Subject: UniStar Nuclear Energy, NRC Docket No. 52-016  
Response to Request for Additional Information for the  
Calvert Cliffs Nuclear Power Plant, Unit 3,  
RAI 253, Seismic System Analysis

**Response to NRC Request for Additional Information  
RAI No. 253, Question 03.07.02-45, Seismic System Analysis  
Calvert Cliffs Nuclear Power Plant, Unit 3**

**COLA Markup Changes to CCNPP Unit 3 COLA Part 2 and Part 10 Associated  
with the Response to RAI 253, Question 03.07.02-45,  
Calvert Cliffs Nuclear Power Plant, Unit 3**

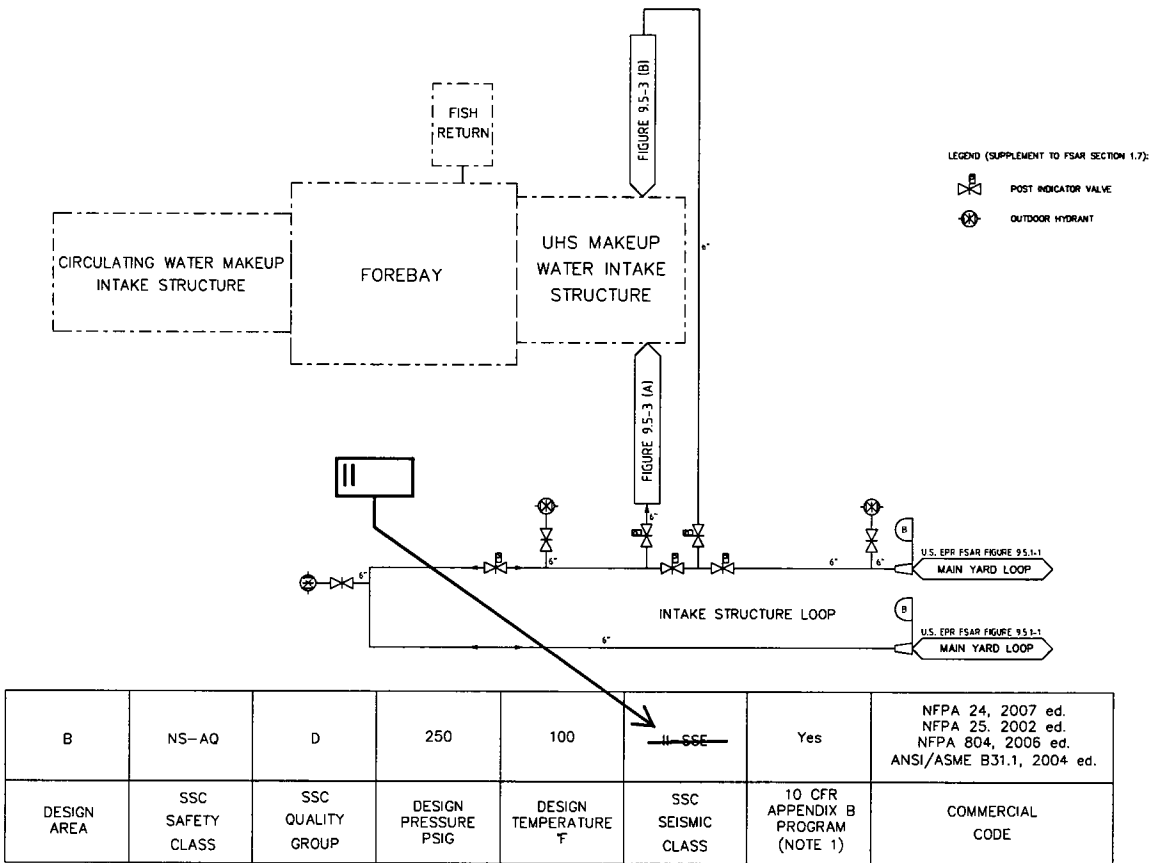
Figure 9.5-1 illustrates the site-specific fire main yard loop supplying the Cooling Tower area. This non-seismic loop supplies the sprinkler system protecting the Water Treatment Building as well as the yard fire hydrants.

Figure 9.5-2— {CCNPP Unit 3 Fire Water Distribution System – Intake Structure Loop}

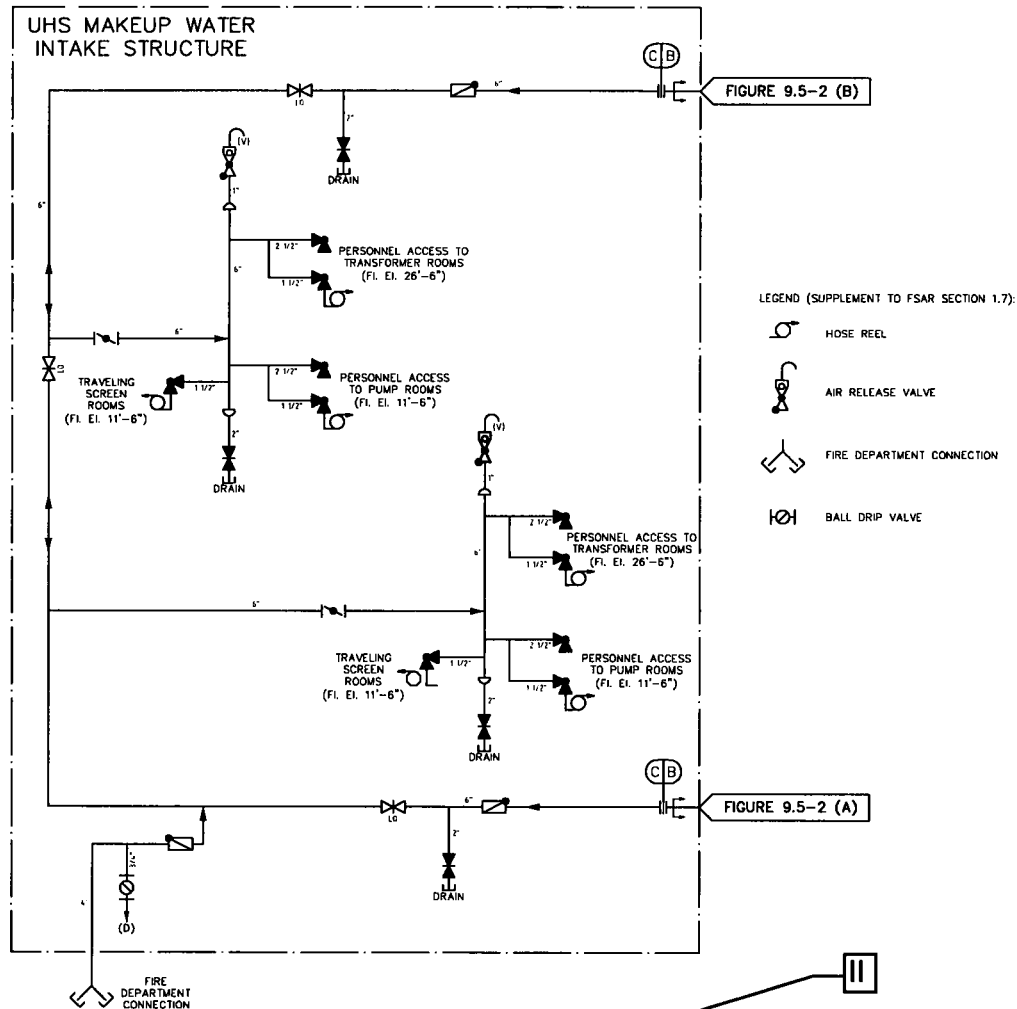
Figure 9.5-2 illustrates the site-specific fire main yard loop supplying the Intake Structure area. The ~~Seismic Category II-SSE~~ loop supplies fire water to the above ground manual and automatic suppression systems identified in Figure 9.5-3. This figure illustrates the ~~Seismic Category II-SSE~~ standpipe and hose stations and the Seismic Category II sprinkler systems specified for the UHS Makeup Water Intake Structure.}

CC3-11-0221	Table 3.11-1	Incorporate COLA markups associated with the response to RAI 253.	The response to RAI 253 Question 03.07.02-45 involved deleting text associated with the seismic category of "SII-SSE" and replacing it with "CS (Conventional Seismic)" in Note 3 of Table 3.11-1 (page 9 of 9).
CC3-11-0221	9.4.16.1	Incorporate COLA markups associated with the response to RAI 253.	The response to RAI 253 Question 03.07.02-45 involved deleting the term "Seismic Category II-SSE" from the first paragraph in Section 9.4.16.1.
CC3-11-0221	9.5.1.2.1	Incorporate COLA markups associated with the response to RAI 253.	The response to RAI 253 Question 03.07.02-45 involved deleting the term "Seismic Category II-SSE" from the last paragraph in Section 9.5.1.2.1.
CC3-11-0221	Figure 9.5-2	Incorporate COLA markups associated with the response to RAI 253.	The response to RAI 253 Question 03.07.02-45 involved deleting the term "II-SSE" and replacing it with "II" in FSAR Figure 9.5-2.
